TECHNICAL BULLETIN

MODEL/DERIVATIVE:
Freelander

Bulletin No: 0005
CDS. ref: L8628bu
Issue: 1
Date: 02.05.01

PROBLEM:
TRANSMISSION CHATTER AT LOW ENGINE SPEED - DRIVEN PLATE

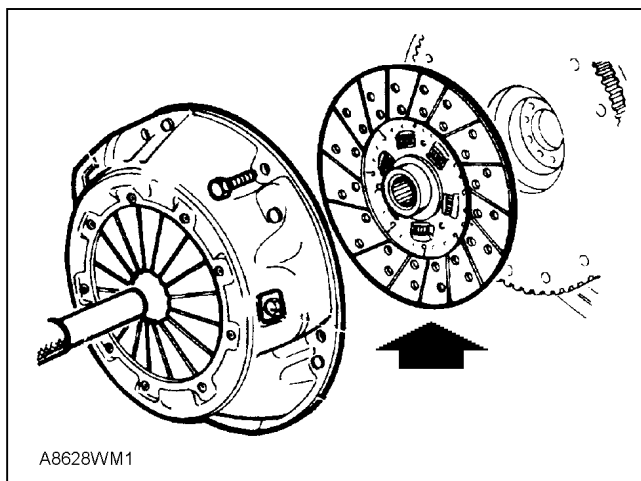
The customer complains of a chatter or rattle noise at low engine speed or when idling. May be incorrectly diagnosed as engine rattle.

CAUSE:
Insufficient internal damping of the clutch driven plate.

ACTION:
Confirm cause by gradually raising engine speed, chatter noise should quickly disappear. The noise will also cease when the clutch pedal is depressed.

If the condition is confirmed, replace the clutch driven plate for the new part detailed in *PARTS INFORMATION*.

PARTS INFORMATION:
UQB101070 Clutch driven plate
